Amendment of Request for Bids - Works
(Two-Envelope Bidding Process, Without Prequalification)
(International Bid)

Contract title: Development & Expansion of Burimari Land Port- Construction of Parking
Yard, Sheds, Warehouses with other ancillary facilities

Amendment of RFB Documents

Queries/ Requests by the Bidders and Clarifications/ Responses by the ACCESS-BLPA Project on the RFB Documents.

DRAWING NO: **03: A-03** SCALE : AS SHOWN DATE: **20.07.2024**
PAPER : A1 REV: **02**

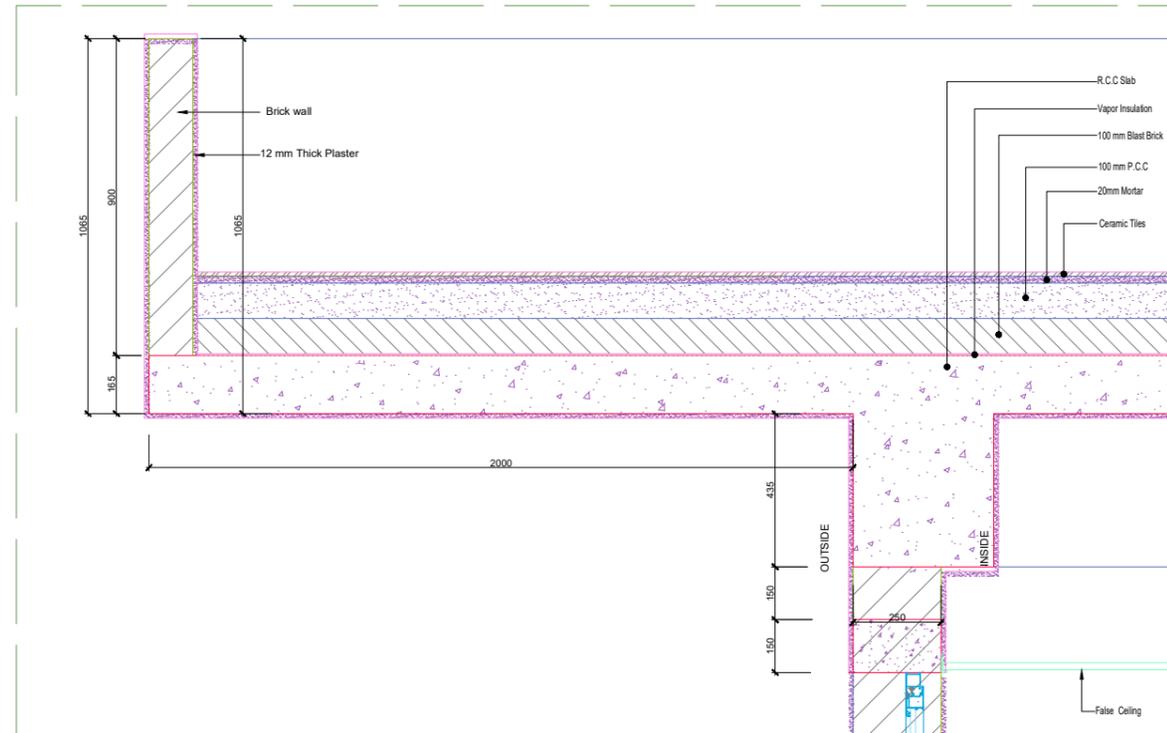
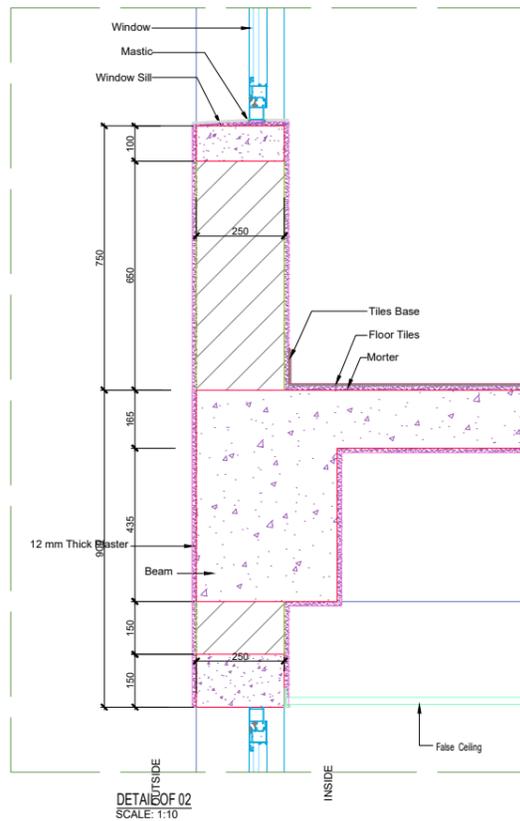
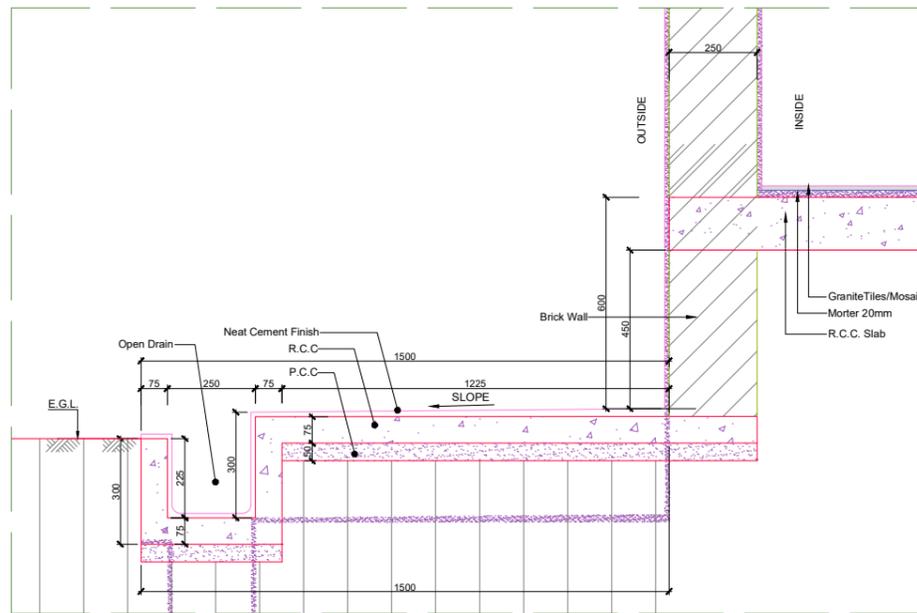
48.	List of missing page in drawing, 1: Architecture, Please provide the missing page titled 03: A-03	The missing drawing is attached with the amendment of RFB

DRAWING NO: TCLS-STR-15	SCALE: NOT TO SCALE	DATE: 25.07.2024
		REV: 02

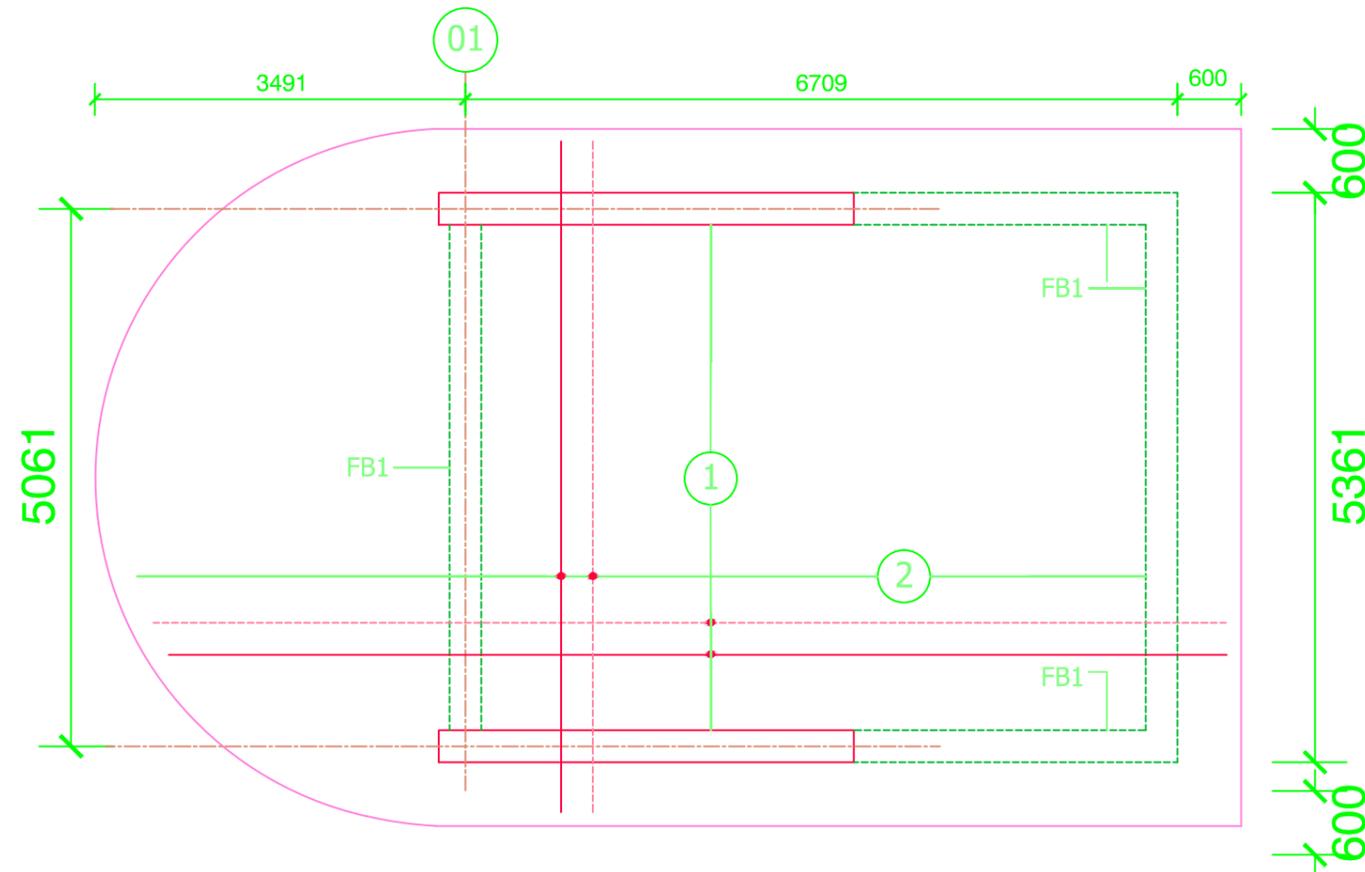
49.	List of missing page in drawing, 2 Structure, Q: Please provide the missing page titled TCLS STR 14-15	The missing drawing is attached with the amendment of RFB
